ARKANSAS NUCLEAR ONE, UNIT 2

AMENDMENT TO FACILITY OPERATING LICENSE

Amendment No. 33
License No. NPF-6

ATTACHMENT TO LICENSE AMENDMENT NO. 33

FIGURE 3.3-1

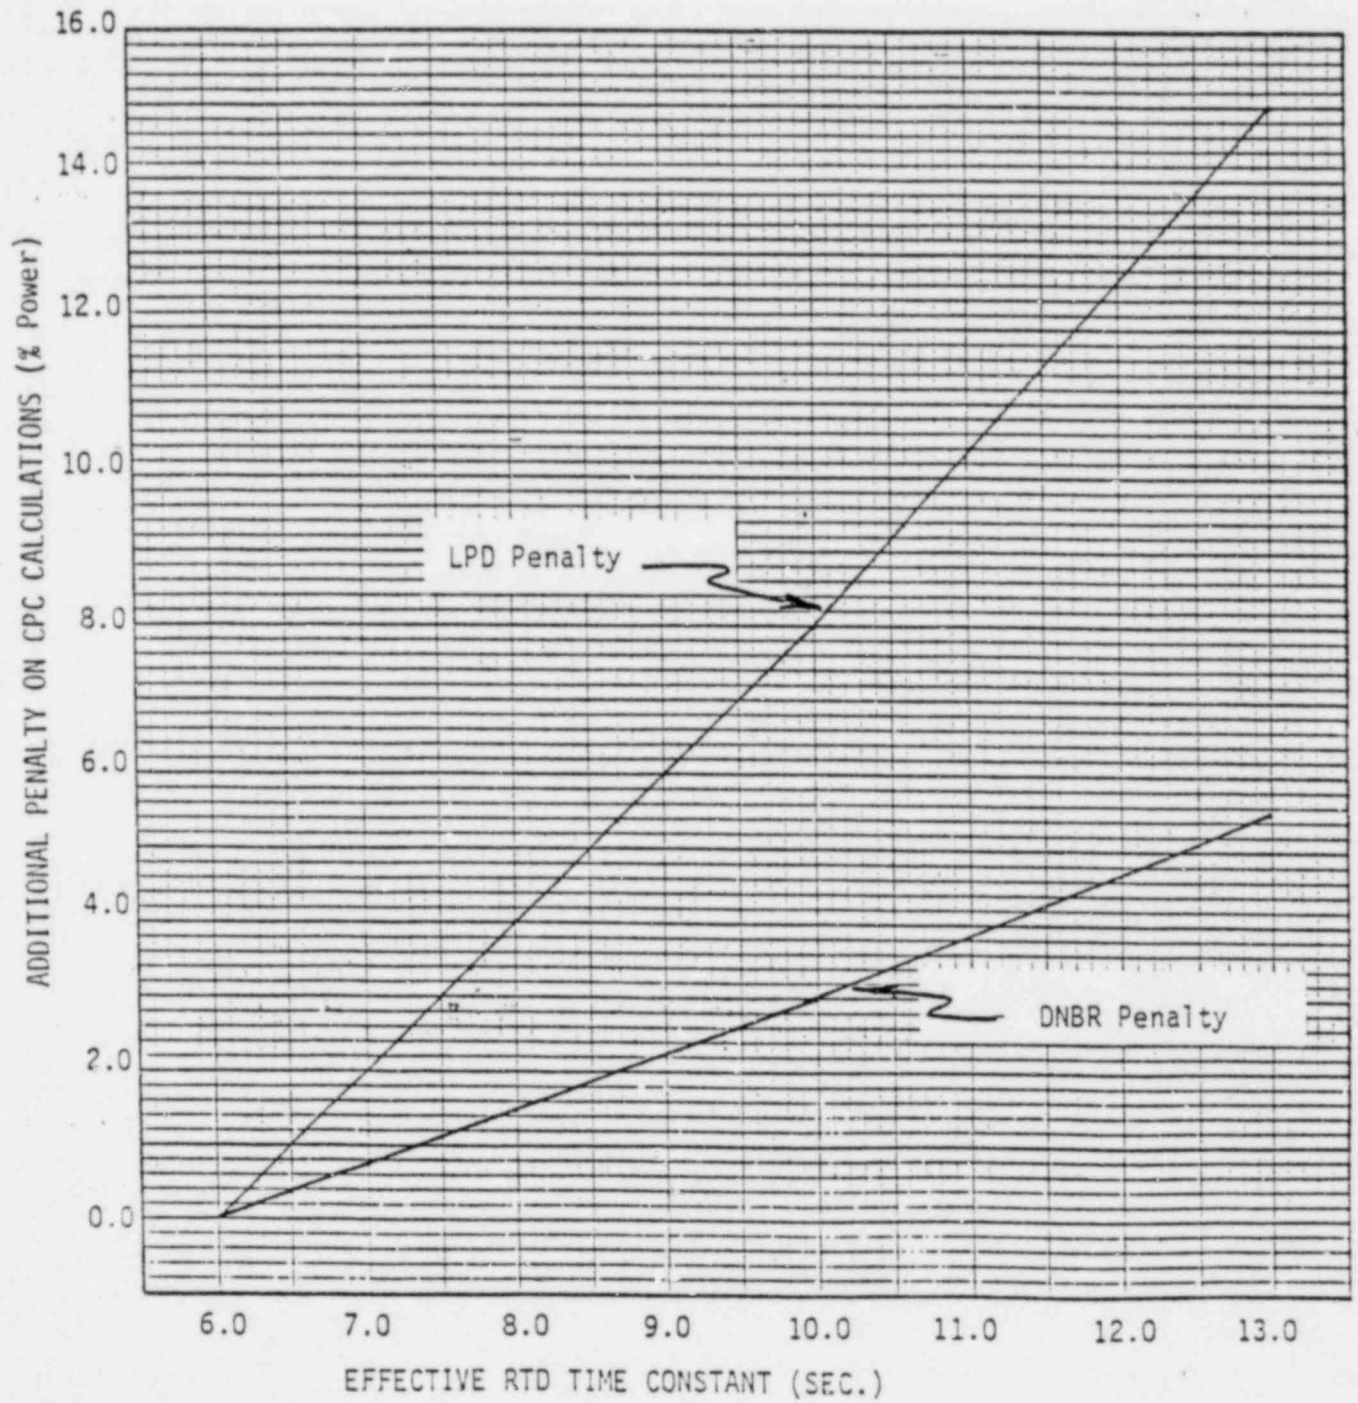
If the effective RTD time constant for a CPC channel exceeds 6.0 seconds, the DNBR and LPD penalties for the affected channel(s) shall be increased by the amount indicated on Figure 3.3-1, and the Power Operating Limit on DNB will be decreased by the amount shown in Table 3.3-3.

The RTD response time for the Core Protection Calculator System (CPCS) is expressed as an effective time constant. The effective time constant is determined based on the utilization within the CPCS calculations. For hot leg temperatures, the effective time constant to be used in Figure 3.3-1 for a given CPC channel is determined from the mean time constant for averaged pairs of hot leg RTD inputs to the channel. This is done because the CPCS utilizes the mean hot leg temperature in its DNBR and LPD calculations. For cold leg temperatures, the effective time constant to be used in Figure 3.3-1 may be considered to be the smaller time constant of the two cold leg RTD inputs for a given channel. This is due to the fact that the CPC utilizes either the maximum cold leg temperature or the minimum cold leg temperature in its various DNBR and LPD calculations for conservatism. However, for asymmetric steam generator protection, the maximum time constant of the two cold leg RTDs input to a given channel must be used in Table 3.3-3 since the CPC utilizes both cold leg RTD inputs in this calculation.

<u>Effective RTD Time Constant (Seconds)</u>	<u>Penalty (% Power)</u>
≤ 6.0	0
$6.0 < \tau \leq 8.0$	4
$8.0 < \tau \leq 10.0$	5
$10.0 < \tau \leq 13.0$	9
